**GENERAL
CORRESPONDENCE**

STATE OF NEW MEXICO

OIL CONSERVATION DIVISION
AZTEC DISTRICT OFFICE

**RE: Bonding Requirements
T-n-T Disposal Facility
Rio Arriba County, New Mexico**

| 5/29/92 | | SHEET 1 | |

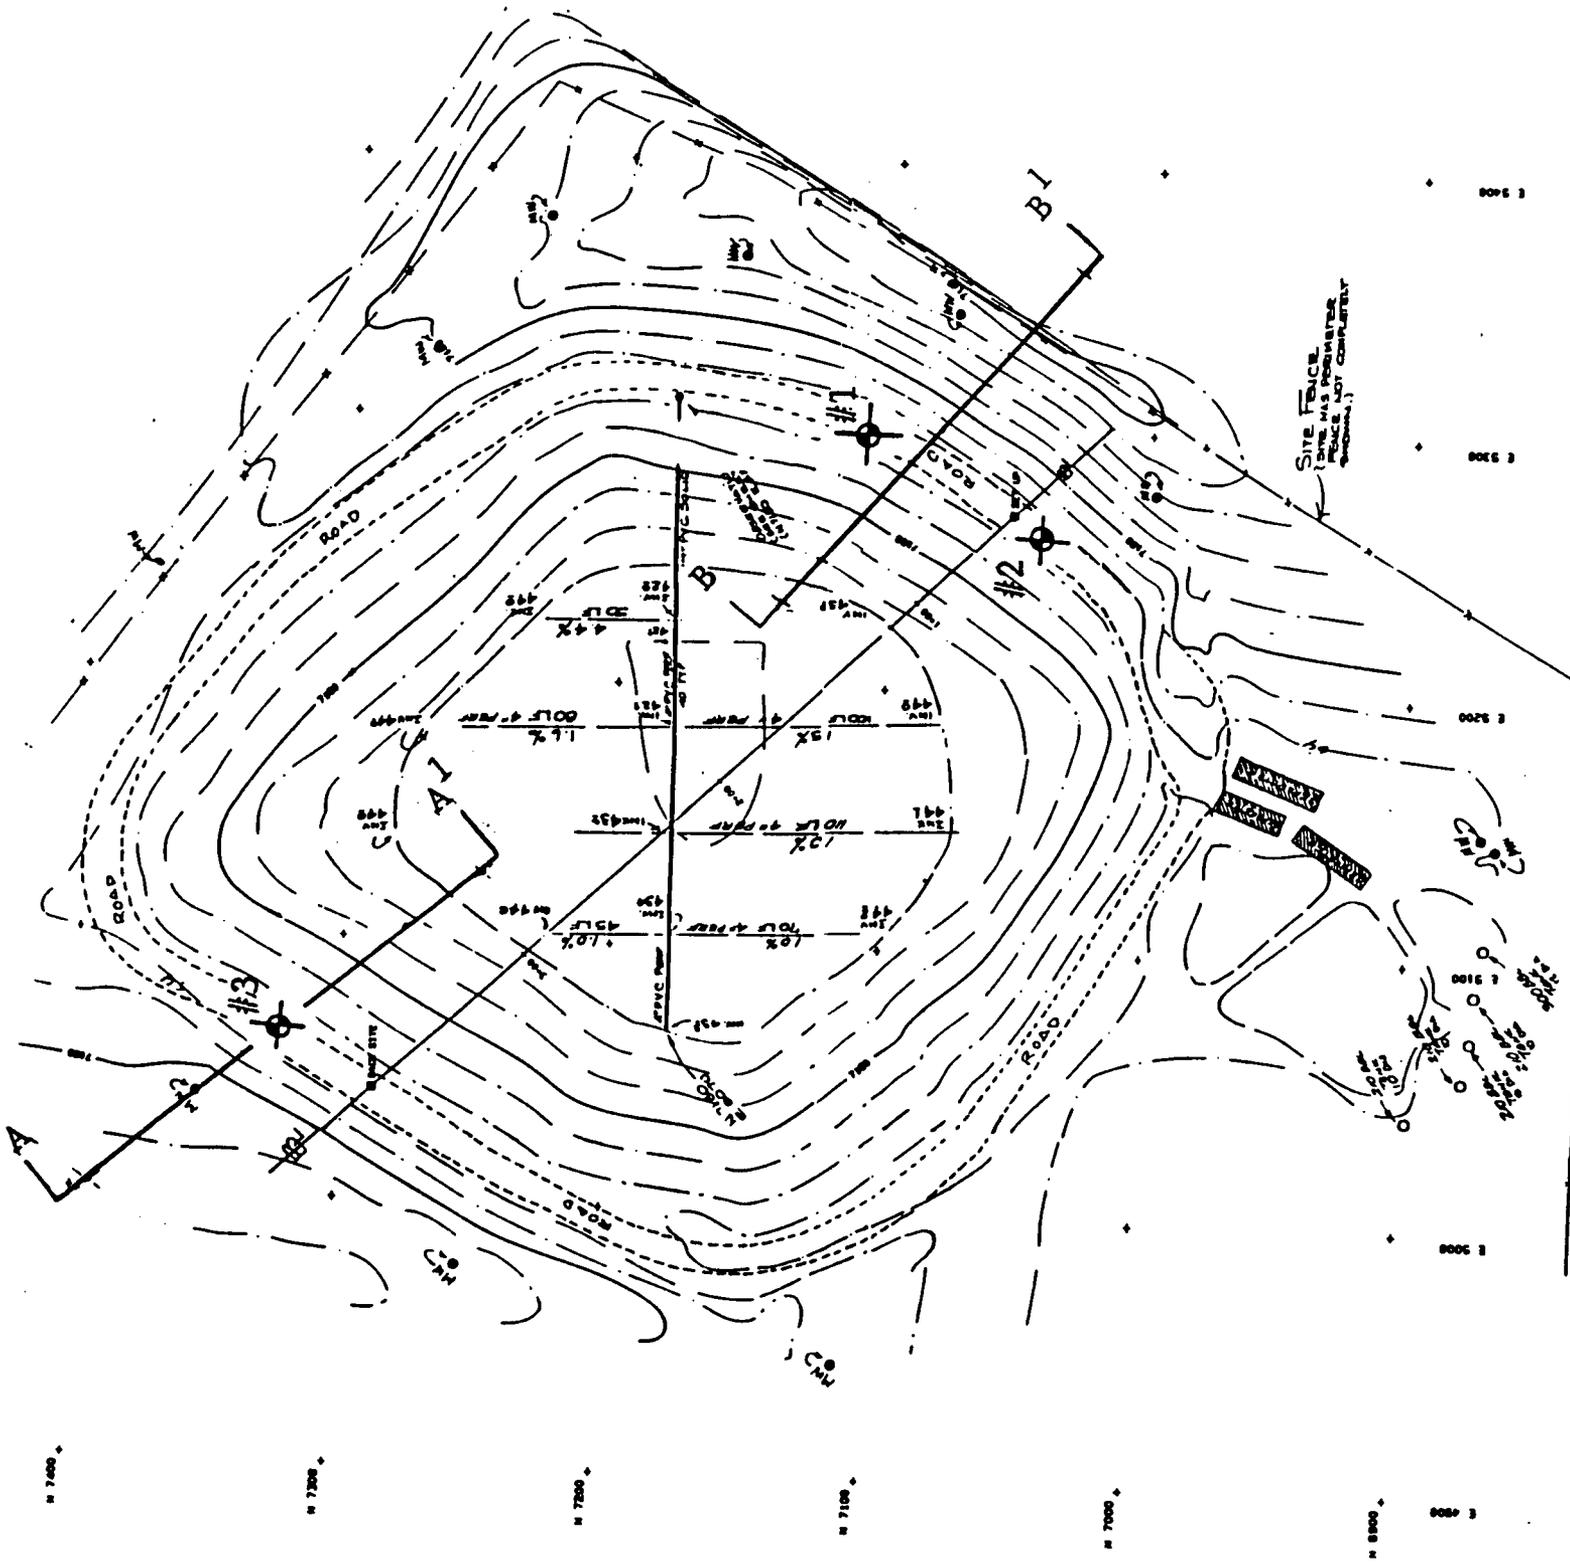
Your comment referred to the spacing of the leak detection laterals. I have added a dimension of "40 feet (max)" to the Plan Sheet 1. Enclosed is a copy of Sheet 1 showing this revision highlighted.
